Subject: **Advanced Disposal Services – Arbor Hills Landfill, Inc.**  
Response to Third Quarter Inspection FY 2019 – Violation Notice (VN)  
Arbor Hills West Expanded Sanitary Landfill; Facility ID 475946

This letter responds to the Violation Notice (“VN”) dated May 24, 2019 as a result of the Third Quarter Inspection FY2019 conducted on May 9, 2019. The VN alleges that ADS is in violation of the provision of Part 115 and the administrative rules, citing certain exceedances of leachate levels in Cell 3 over the months of January to Mid-April, in addition to continued exceedances in Cell 4.

**ADVANCED ARBOR HILLS LANDFILL**  
 SALEM TOWNSHIP, WASHTENAW COUNTY, MICHIGAN  
 EXISTING LEACHATE COLLECTION SYSTEM

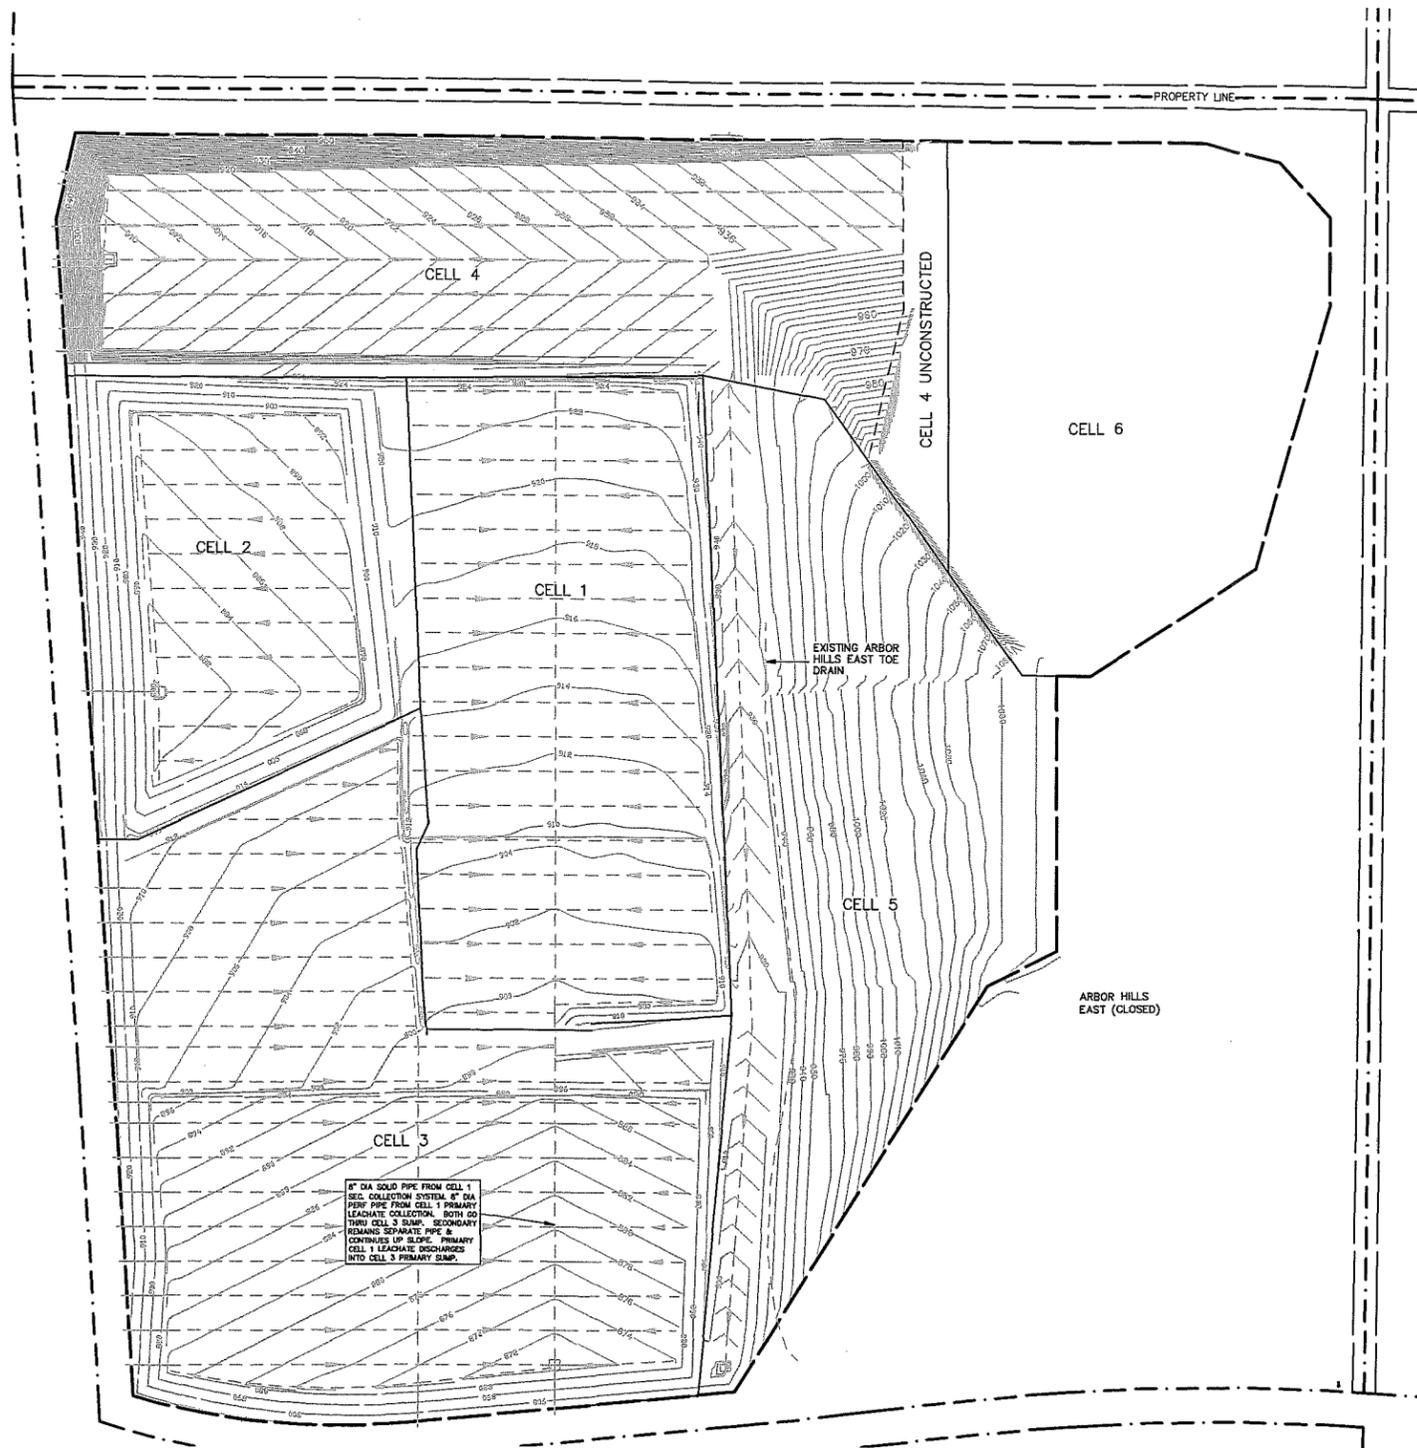
6. Documentation/confirmation based on as-built information as to the fate of leachate from the Cell 1 primary liner system.

As depicted and noted on Attachment 2, Existing Leachate Collection System drawing, an 8" diameter solid pipe from Cell 1 secondary collection system and an 8" diameter perforated pipe from Cell 1 primary leachate collection both go to the Cell 3 sump. The secondary remains a separate and continues upslope while the primary Cell 1 leachate discharges into Cell 3 primary sump.
